**ADDENDUM #5**

**T-20-122**

**FOR: Construction of a New Elevator and 2nd Floor AODA Washroom**

ELECTRICAL ADDENDUM NO. E-002 R1

Drawing Title: SECOND FLOOR - LIGHTING LAYOUT

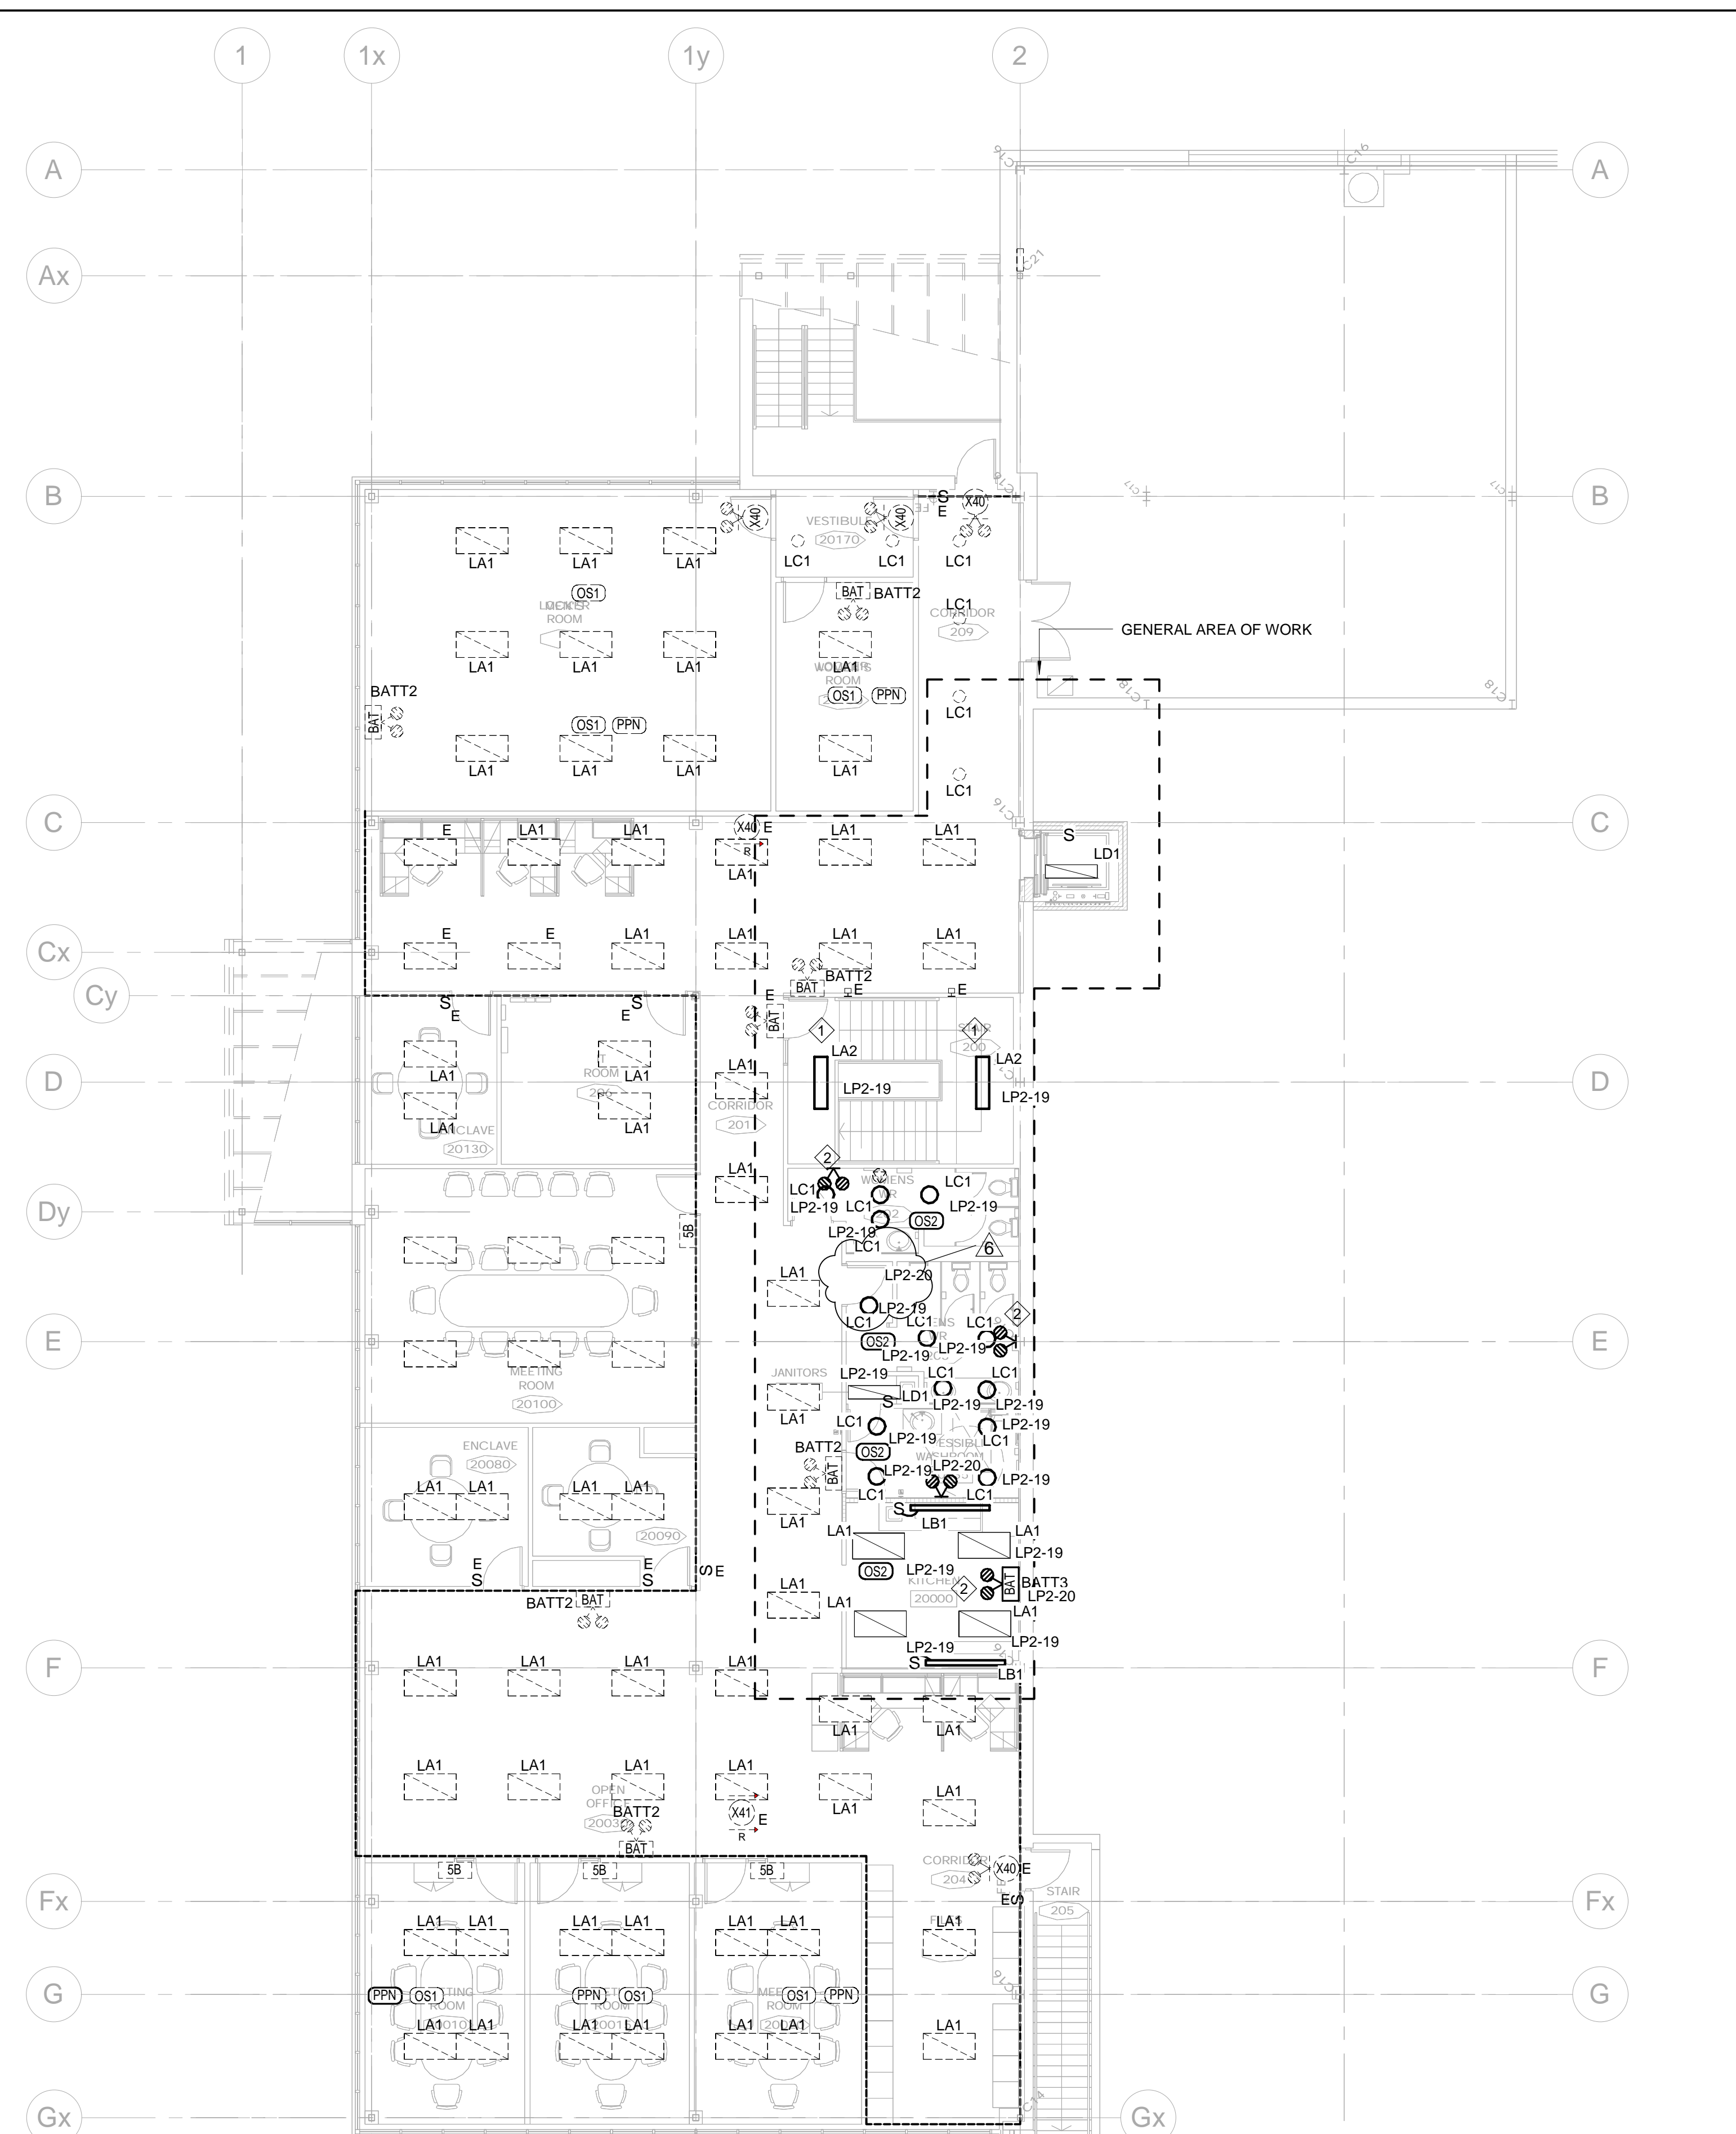
**Q12.** Some light fixtures shown in the 'General Work Area' on drawing 'E101' are not bolded (Type 'LA1' and LD1'). Please confirm these are new fixtures, or re – used from demolition.

- a. Drawing E001 – Electrical legend, notes and Lighting fixtures schedule
  1. Lighting fixture schedule has been updated.
- b. Drawing E100 – Ground Floor-Lighting layout
  1. Exit sign types have been revised.
- c. Drawing E101 – Second Floor-Lighting layout
  1. Exit sign type X11 has been deleted.
  2. General notes have been revised.
- d. Drawing E200 – Ground floor-Power and Systems layout
  1. Circuits have been revised.
  2. Type of data drop located on the west wall of Enclave room 10049 has been revised.
  3. Breaker and Feeder sizes for hydraulic elevator have been specified.
  4. Keynotes have been revised.

**A12.** Items not shown as dashed lines (- - - -) are existing, to remain. Light fixtures LA1 and LD1 shown with solid continuous lines are new.

- 1.1 E001 – Electrical legend, notes and Lighting fixtures schedule
  - 1.1.1 Lighting fixture schedule has been updated.
- 1.2 E100 – Ground floor-Lighting layout
  - 1.2.1 Exit sign types have been revised.
- 1.3 E101 – Second floor-Lighting layout
  - 1.3.1 Exit sign type X11 has been deleted.
  - 1.3.2 General notes have been revised.
- 1.4 E200 – Ground floor-Power and Systems layout
  - 1.4.1 Circuits have been revised.
  - 1.4.2 Type of data drop located on the west wall of Enclave room 10049 has been revised.
  - 1.4.3 Breaker and Feeder sizes for hydraulic elevator have been specified.
  - 1.4.4 Keynotes have been revised.

Drawing Title:  
**GROUND FLOOR - POWER AND SYSTEMS LAYOUT**

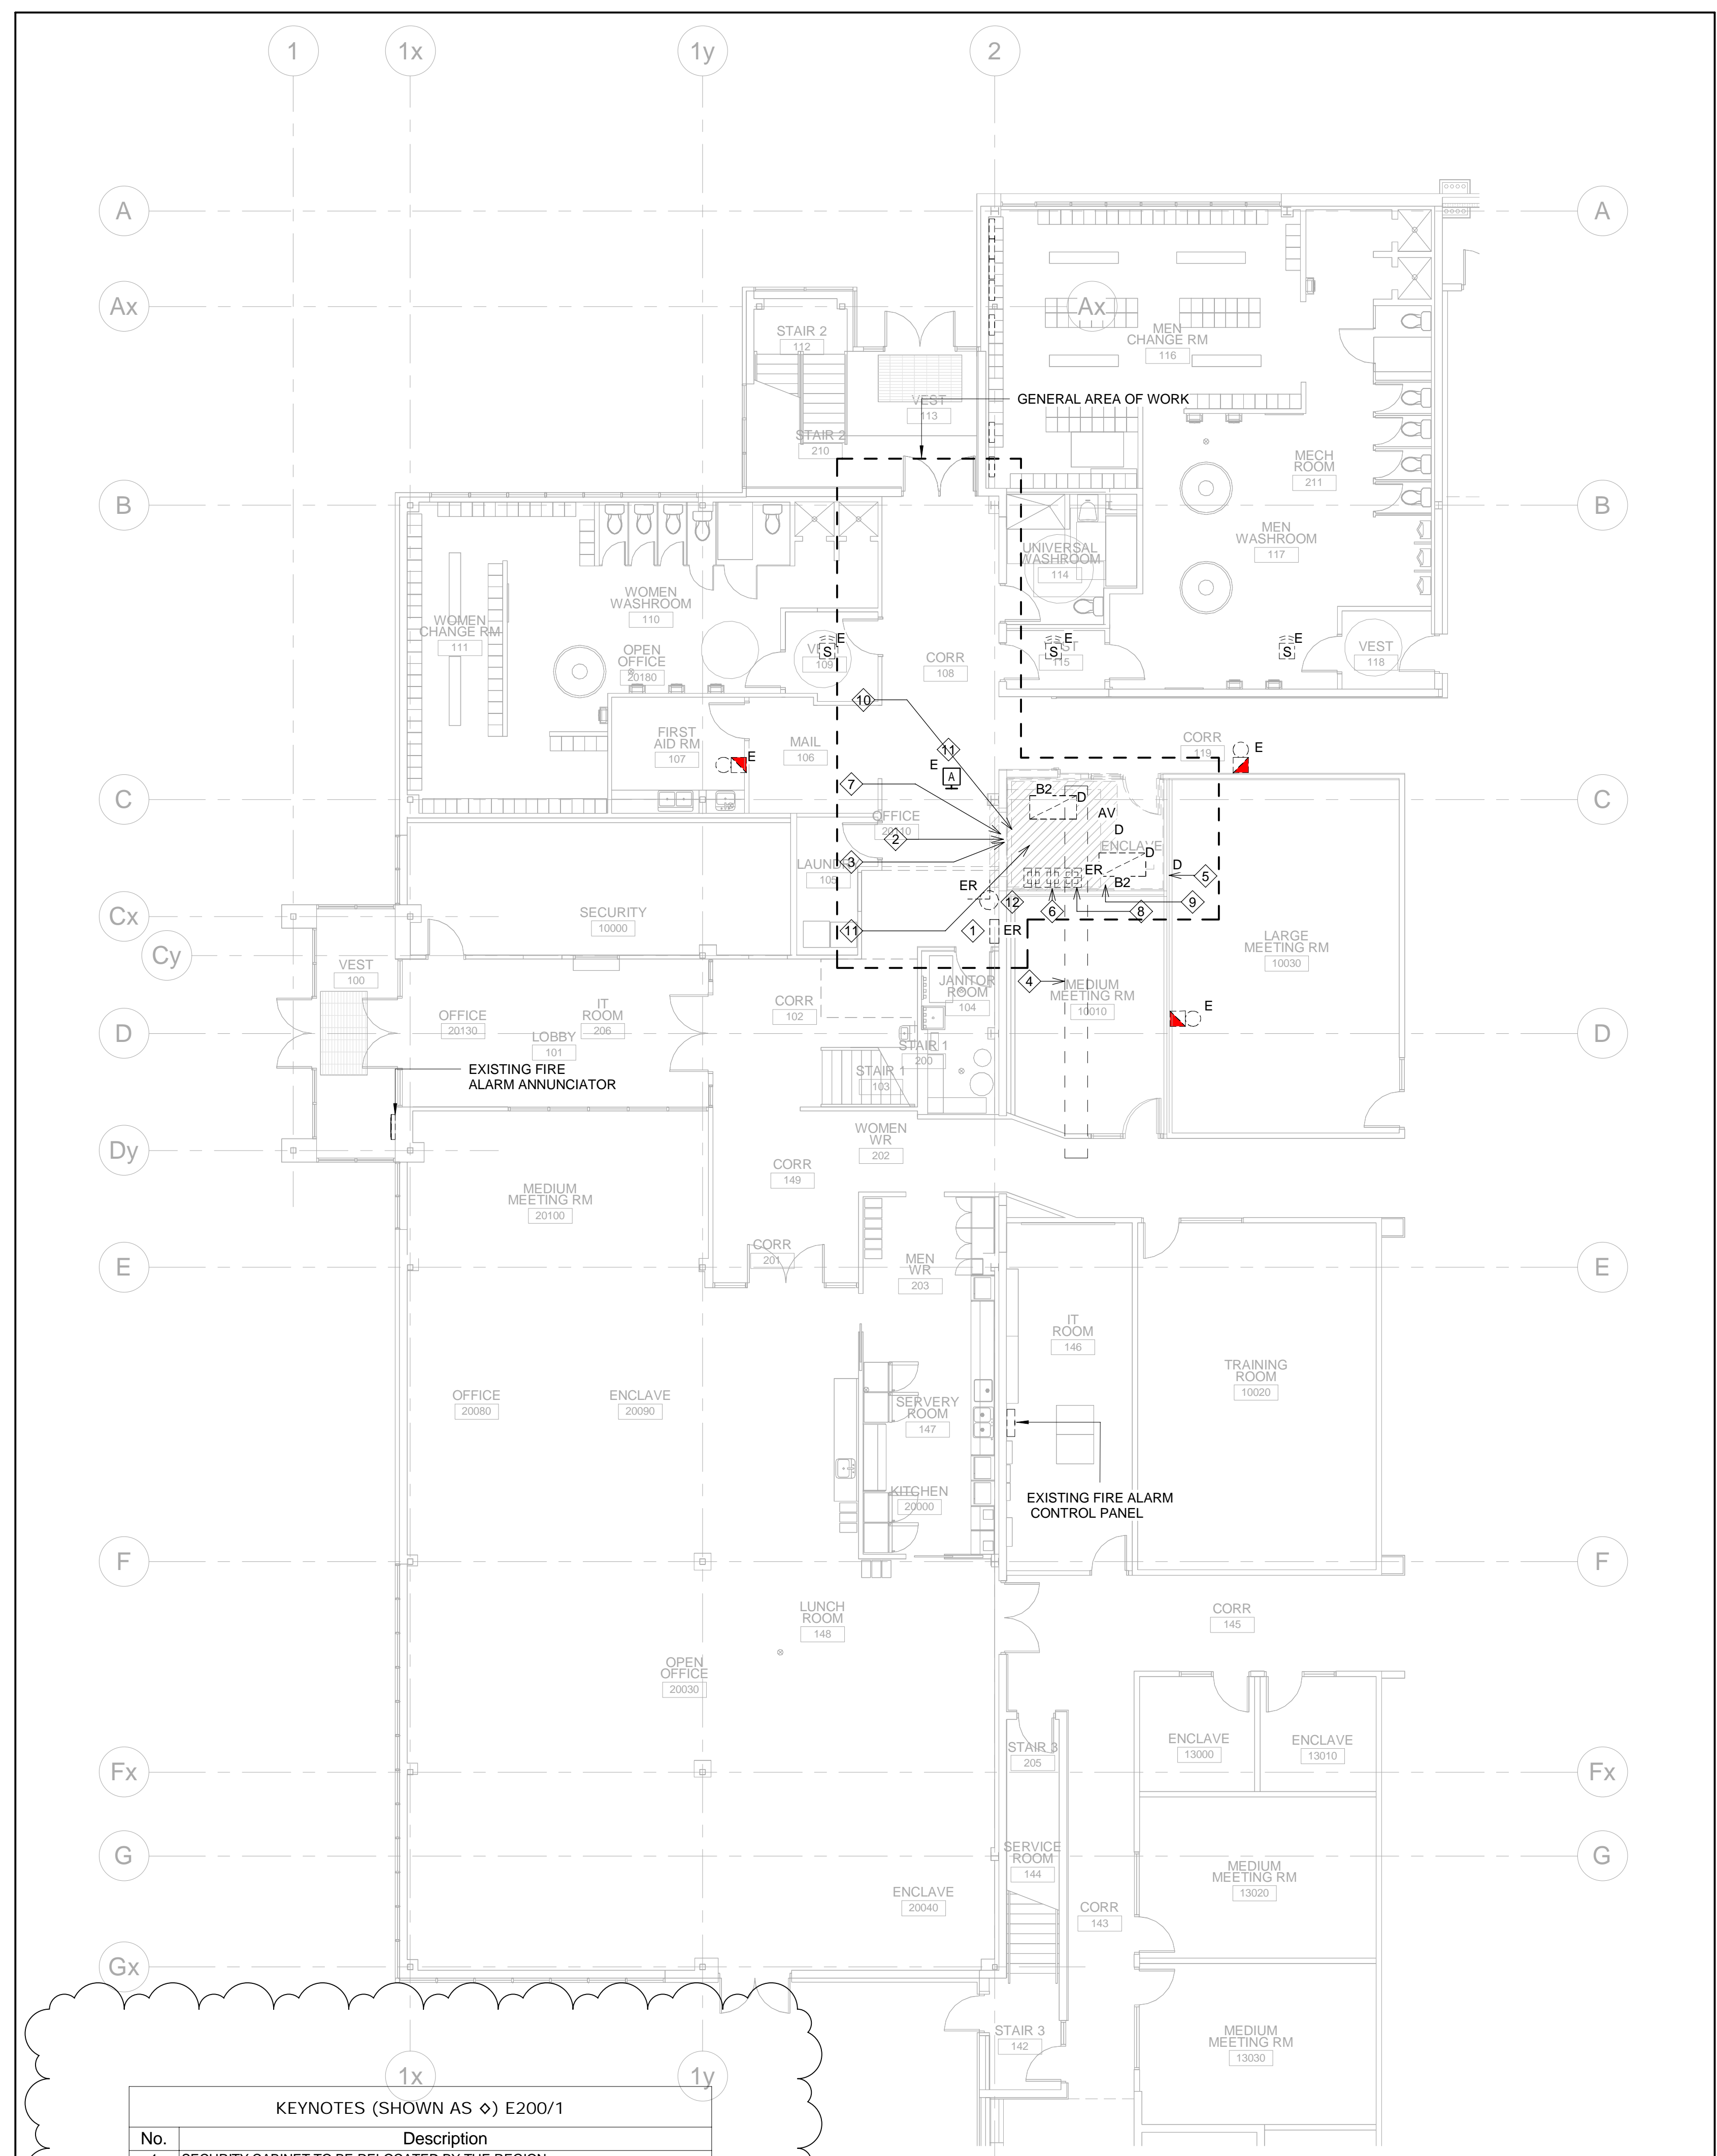
- Q6.** What is the power requirement for the elevator? Voltage is listed but neither the amperage or wattage is stated.

- A6.** 40A (amps)-3p (pole) breaker and cable to be provided for elevator.
- Q7.** Please provide specifications for fixtures X11, X12 and LB1
- A7.** See attached revised drawings
- Q8.** What is the electrical schedule of Panel PP4?
- A8.** References to PP4 to be revised to RP4. The existing panel information is provided in the documents.
- Q9.** Could you please clarify the highlighted symbols below located on drawing E200 ?

**Q14.** Please clarify what is tagged 'FAC' on drawing E200.

- A9.** The 'FAC' is the fire alarm connection to the elevator controller for homing. The other data device has been clarified, to be wall mounted data connection. See attached revised drawings.

No.	Description
1	PROVIDE LOCAL FUSED DISCONNECT WITH AUXILIARY CONTACTS AND WIRING TO ELEVATOR CONTROLLER.
2	PROVIDE RELAY BASE WITH WIRING TO ELEVATOR CONTROLLER.
3	120V, 1PH, 1A WITH FUSED SPST DISCONNECT SWITCH FOR CONTROLLER.
4	208V, 3PH, 60HZ DIRECT CONNECTION, 40A-3P BREAKER AND 3#8 AWG & 1#10 GND CABLE FEED FOR HYDRAULIC ELEVATOR.
5	FOR ELEVATOR CONTROLLER.
